DEPARTMENT OF TRANSPORTATION

Contract #: 04-0120F4Cty: SF/ALA Rte: 80 PM: 13.2/13.9File #: 1.28**WELDING INSPECTION REPORT****Resident Engineer:** Casey, William**Address:** 333 Burma Road**City:** Oakland, CA 94607**Report No:** WIR-028504**Date Inspected:** 25-Sep-2012**Project Name:** SAS Superstructure**OSM Arrival Time:** 600**Prime Contractor:** American Bridge/Fluor Enterprises, a JV**OSM Departure Time:** 1430**Contractor:** American Bridge Manufacturing**Location:** Reedsport, OR**CWI Name:** Harry Woodward**CWI Present:** Yes No**Inspected CWI report:** Yes No N/A**Rod Oven in Use:** Yes No N/A**Electrode to specification:** Yes No N/A**Weld Procedures Followed:** Yes No N/A**Qualified Welders:** Yes No N/A**Verified Joint Fit-up:** Yes No N/A**Approved Drawings:** Yes No N/A**Approved WPS:** Yes No N/A**Delayed / Cancelled:** Yes No N/A**Bridge No:** 34-0006**Component:** Elevator Tower Enclosure frames**Summary of Items Observed:**

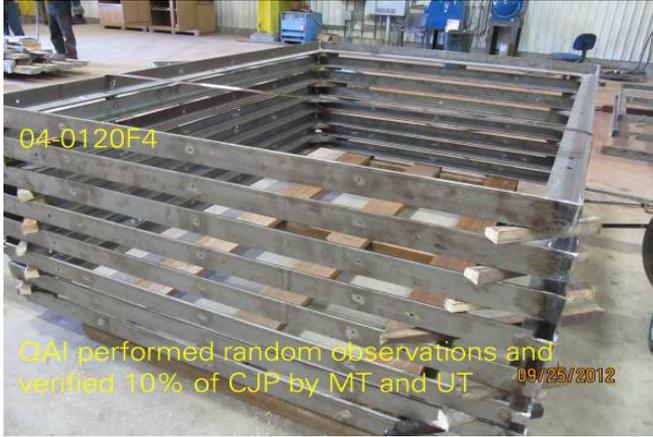
This Quality Assurance Inspector (QAI), Dan Chang, performed a random observation on fabricated Elevator Tower Enclosure frames, CCO 85. Some welds did not appear to meet weld profiles requirements of AWS were discovered. This QAI informed Welding Quality Control Inspector (WQCI), Harry Woodward, of American Bridge Manufacturing (ABM) who directed an ABM personnel to perform addition work on the welds. This QAI performed additional observations after the welds were reworked. The reworked welds appeared to meet the weld profiles requirements of AWS.
